CVOW COP DEIS

Re: Draft Environmental Impact Statement for the Coastal Virginia Offshore Wind (CVOW) Commercial Project (Docket No. BOEM-2022-0069)

PJM and VA change in electric generation fuel source 2009 to 2021, million MWhs

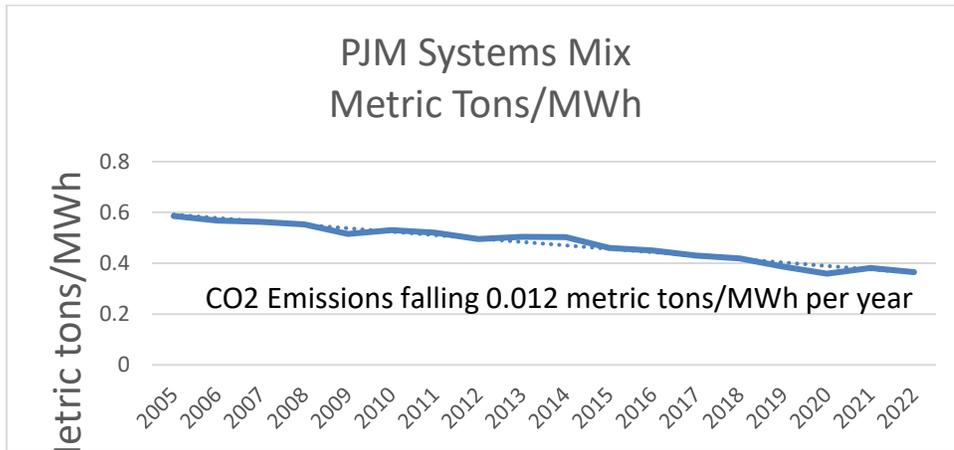
Between 2009 and 2021 all of the emissions reductions in PJM 13 state regional grid and Virginia have come from natural gas replacing coal as seen in the table below. Despite state mandates for wind and solar power by 2021, they only accounted for 2.6% of electric demand, and only covered some of the demand growth. Renewables played little or no role in reducing fossil fuels. With nuclear power projected to decline in the future BOEM and Dominion Energy must demonstrate how this trend will change in the future.

Nuclear plants produce predictable power about 95% of the time compared to CVOW, which is expected to produce power only 42% of the time. The 2,587 MW CVOW project will generate about 9.5 million MWhs/year. According to the Virginia utility commission² CVOW will cost electric customers \$21.5 billion over 35 years for a premium cost of about \$614 million a year, or a guaranteed price of \$64.50/MWh. This is approximately three times more than the per MWh cost of electricity produced by existing nuclear power plants.

The chart above indicates that the power from CVOW will, at best, replace imports from other PJM regional grid states.

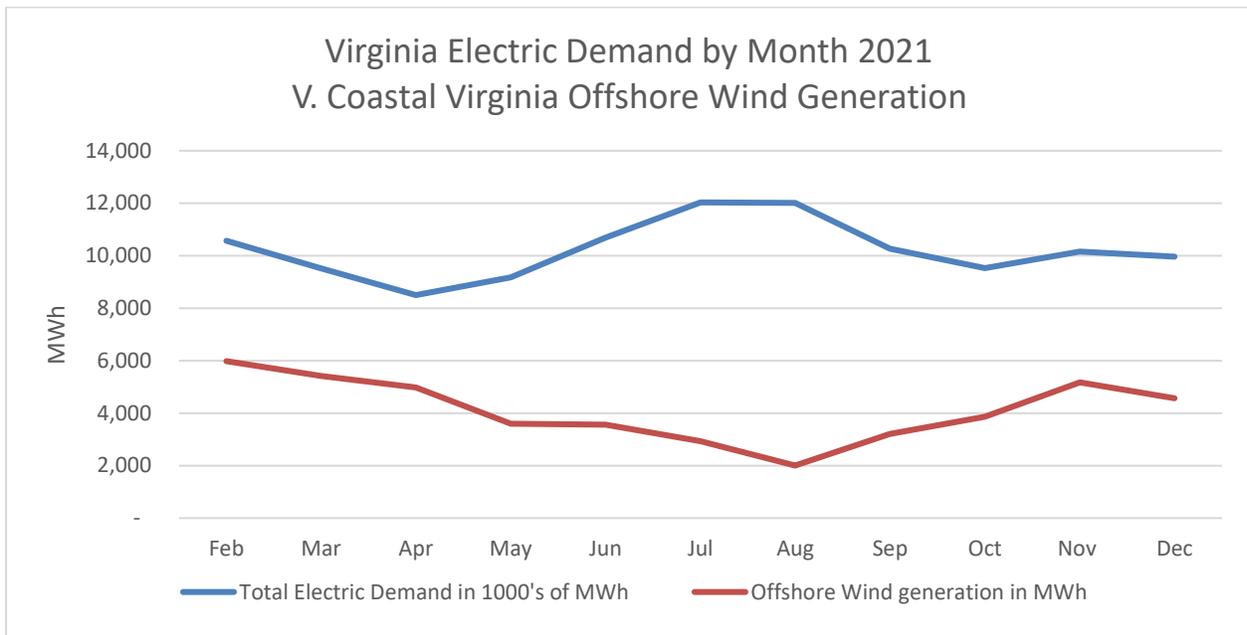
imported from the regional grid so the project will only save about 2.9 million metric tons of carbon dioxide a year. Electric customers will pay \$21.5 billion, and taxpayers will pay another \$2.9 billion in tax subsidies to save that 2.9 million tons a year for an outrageous cost of almost \$8,400/ton.

The chart below was produced using actual operations data from the CVOW prototype project. It shows that offshore wind generates the least amount of power in the summer when it is most needed. Dominion has not released time of day power generation data which also might be occurring when it is least needed. California often produces so much renewable power when it is not needed it must curtail (shut down) generation. The New York Independent System Operator³ is projecting offshore wind will have to be curtailed some of the time. Dominion needs to release generation time of day information and project curtailment rates for the CVOW.

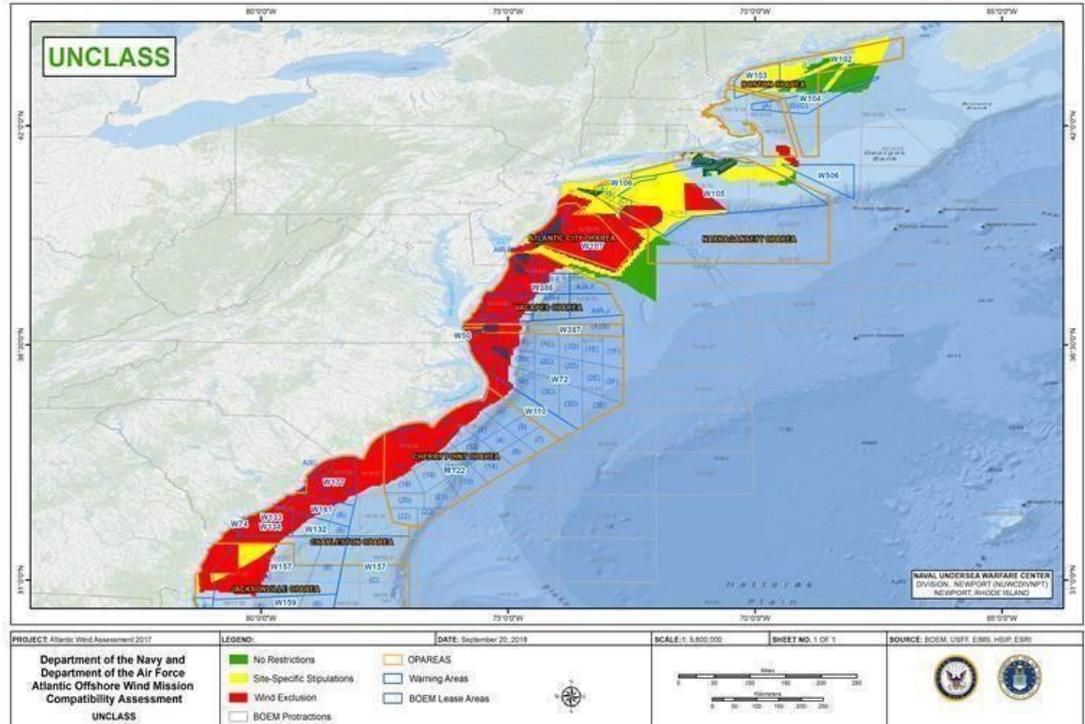
According to the DEIS, “Proximity to the turbines is the primary factor that determines the degree of radar signal degradation. Smaller vessels operating in the vicinity of the Project may experience radar cluttering and shadowing.” The impacts on radar are currently listed as minor.

Following is a summary of the key issues of radar interference by offshore wind turbines. There are major unknowns exacerbated by the fact the largest installed turbines are only about 600’ tall while the turbine proposed for CVOW range between 850’ and 1,040’ with equivalently larger blade diameters. Study titles are underlined with quotation marks for direct quotes.
